**ADDENDUM NO. 3**

Invitation to Bid (ITB) 21-101396 Scott Candler Water Treatment Plant Electrical Building No. 2 Structural Design Improvements and Distribution System Panels Installation (Multiyear Contract) is hereby amended as follows:

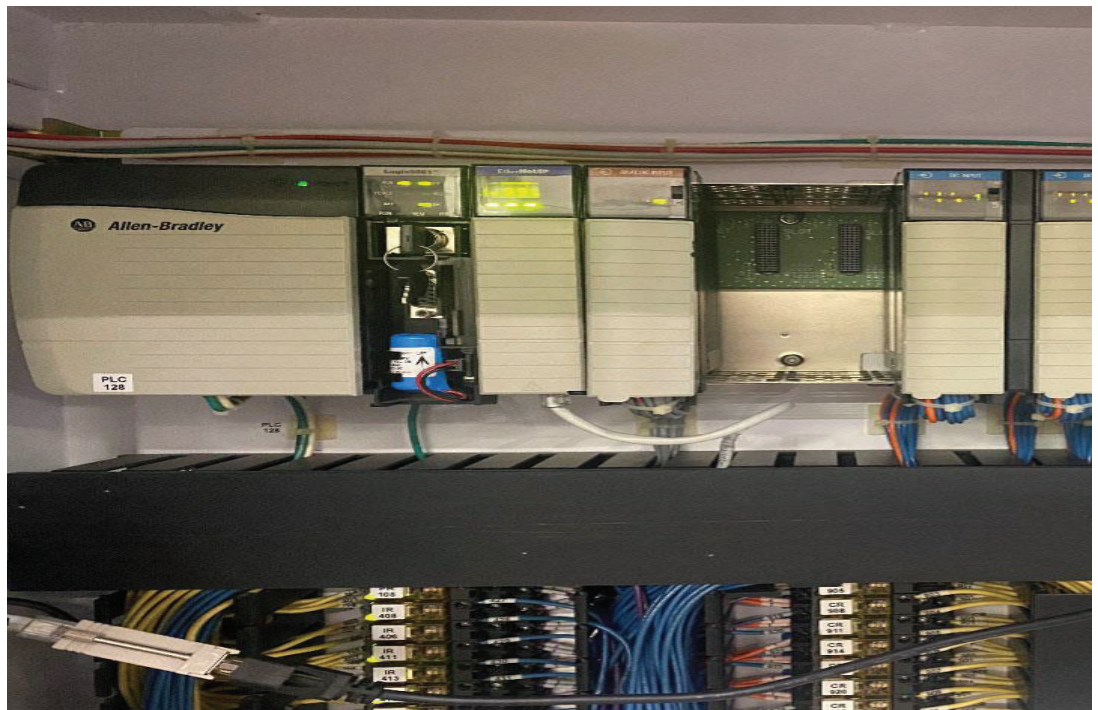
3. Question: For the Controllogix system at Lithonia - Ground Storage Tank, Does it have enough spare slot in the Chassis for the additional AI card? If not, how many existing card in the system?

Answer: Yes. The Controllogix at Lithonia has additional slots for an AI card. Below is a picture of the PLC and Rack.
